## **Modification of Development Consent**

For the following: Walla Walla Solar Farm

Modification: SSD-9874-Mod-1: Increase in solar panel height

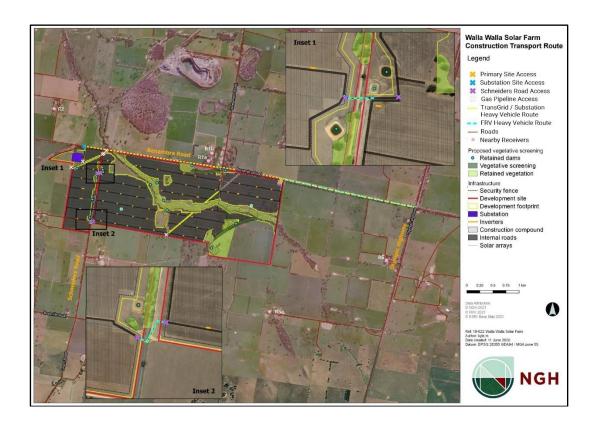
7. In Appendix 5: Over-Dimensional and Heavy Vehicle Access Route Restrictions, replace the map with the following map:
